ROSWELL ROAD SELF STORAGE

REZONING SITE PLAN

PETITION NO: SLUP-6

ZONING COMMENTS: Staff Member Responsible: Terry Martin, MPA

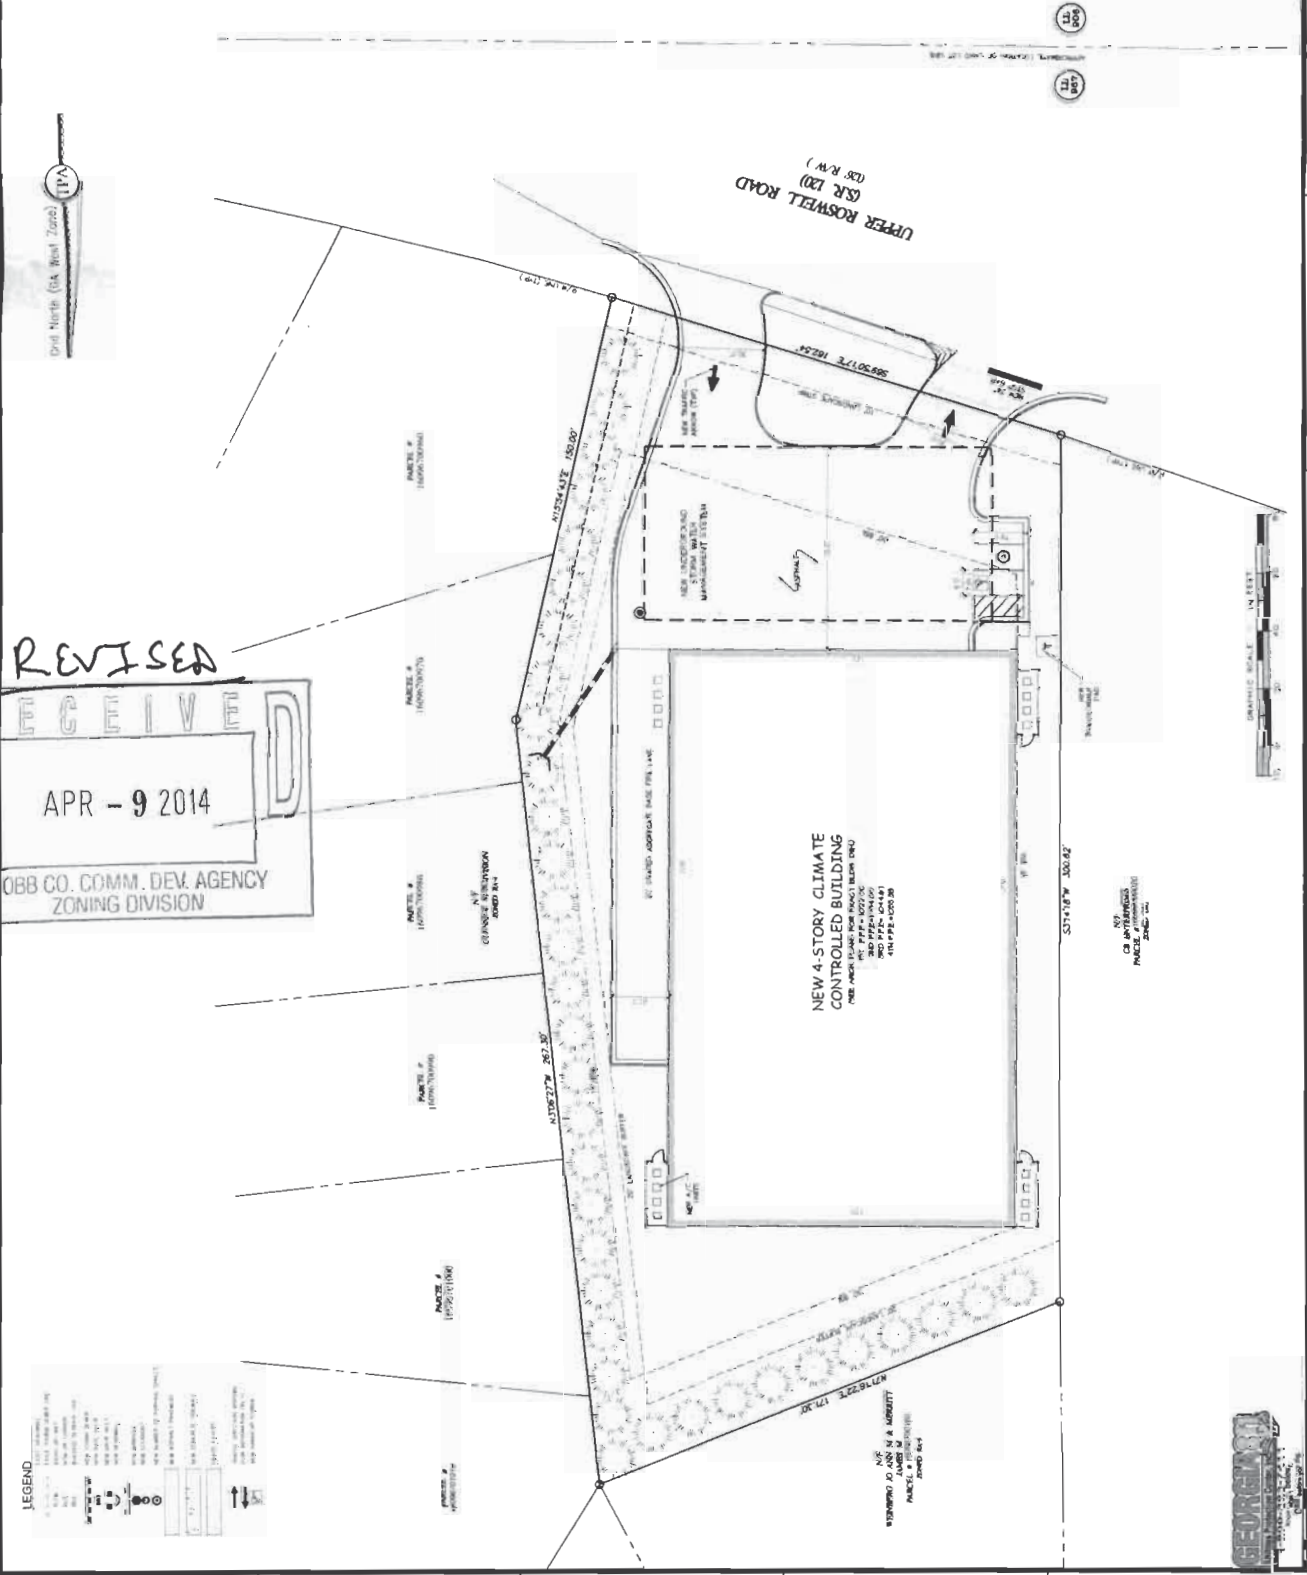
The proposed building height of 51'8" is much higher than those residences immediately located to the west of the subject site. This could be seen as contradictory to the Code's minimum standards of "(not) impact the view shed of adjacent residential property." Also, the proposed floor to area ratio (FAR) is 1.55, well over the 1.0 suggested by the Code. While all units are accessed internally, it is not clear from the applicant's submissions if all windows are "one way" as prescribed by the Code. Too, the Code requires that "architectural style/design to be similar or complementary to the predominant architectural design of other commercial uses within the activity center." The proposed architecture of the storage facility appears more modern with expanses of EIFS, glass, metal accents and modular brick veneer while nearby office uses within the activity center of this portion of Roswell Road and Robinson Road are of a more traditional style of brick construction. A minimal landscaping plan has been provided which shows a 20 foot landscape buffer adjacent to the residential properties to the south and west as well as landscaping of the frontage.

- Provide comprehensive hydrology/stormwater controls to include development of out parcels.
- Submit all proposed site improvements to Plan Review.
- Any **spring activity** uncovered must be addressed by a qualified geotechnical engineer (PE).
- Structural fill _____ must be placed under the direction of a qualified registered Georgia geotechnical engineer (PE).
- Existing facility.
- Project must comply with the Water Quality requirements of the CWA-NPDES-NPS Permit and County Water Quality Ordinance.
- Water Quality/Quantity contributions of the existing lake/pond on site must be continued as baseline conditions into proposed project.
- Calculate and provide % impervious of project site.
- Revisit design; reduce pavement area to reduce runoff and pollution.

- No Stormwater controls shown _____
- Copy of survey is not current – Additional comments may be forthcoming when current site conditions are exposed.
- No site improvements showing on exhibit.

2. The proposed site plan shows the detention facility discharging to the existing drainage easement in the adjacent Glenside Subdivision to the west. The stormwater management design must evaluate and account for the existing conveyance capacity of this older system as well the volume impact on the existing subdivision detention pond. As an alternative the site could be discharged to the existing stormwater system in the Roswell Road R/W subject to the available capacity. The final discharge point must be decided in Plan Review.
